Amendments to the Drawings:

REMARKS

In the Office Action dated November 27, 2006, the Examiner took the following action: (1) objected to the drawings; (2) objected to the abstract; (3) objected to the specification for informalities; (4) rejected claims 10-11 and 14-18 under 35 U.S.C. § 112, second paragraph, as failing to distinctly claim the subject matter; (5) rejected claims 1-6, 8-11 and 14-18 under 35 U.S.C. § 102(e) as being anticipated by U.S. Patent No. 6,824,664 to Austin et al. ("Austin"); (6) rejected claims 7, 12 and 13 under 35 U.S.C. § 103(a) as being unpatentable over Austin in view of U.S. Patent No. 6,368,871 to Christel et al. ("Christel"); (7) rejected claims 1, 3, 5, 9 and 10 for double patenting over claims 1, 3-7, 14, 16-17 and 19-22 of U.S. Patent No. 7,014,747 to Cummings et al. ("Cummings 747") in view of Austin; (8) rejected claims 6 and 14 for double patenting over claims 1, 4 and 5 of copending Application No. 10/176,322 in view of Austin; and (9) rejected claims 1-3 for double patenting over claims 1 and 3-7 of copending Application No. 10/969,137.

FIG. 1

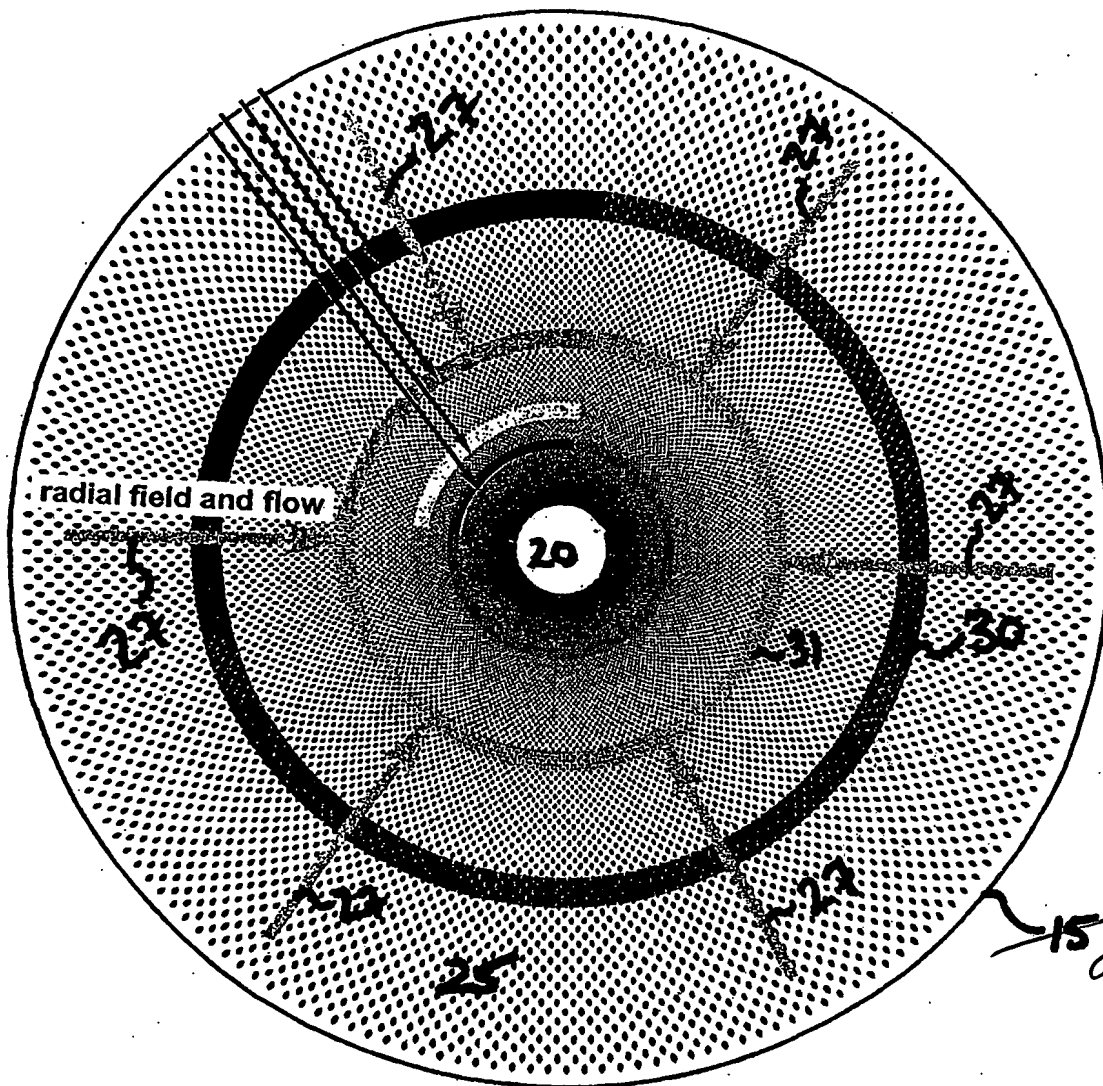
The Examiner objected to the drawings as including reference characters "15" in Fig. 1 and "200" in Fig. 3 not mentioned in the description. Applicants have included amended Figures 1 and 3 with these reference characters removed.

15 delete

The attached sheets of annotated drawings include changes to Figs. 1 and 3. The replacement sheets, which include Figs. 1-4(d), replace the original sheets. In Fig. 1, "15" has been removed; in Fig. 3, "200" has been removed.

FIG. 3

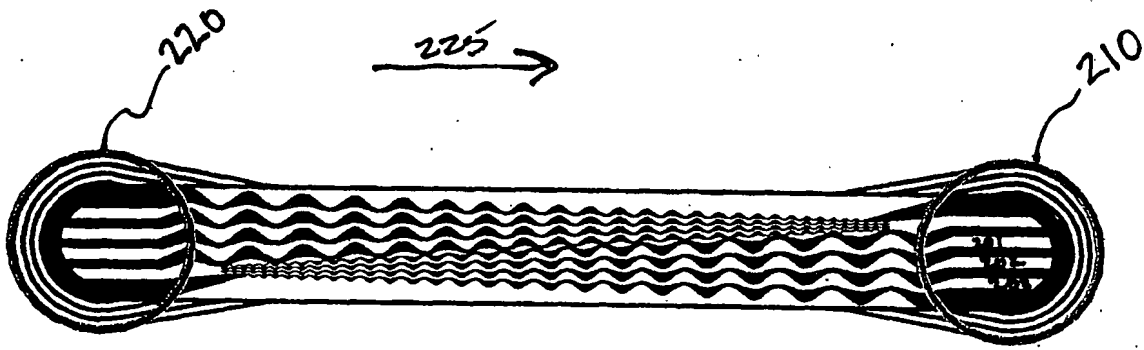
~~200~~
delete
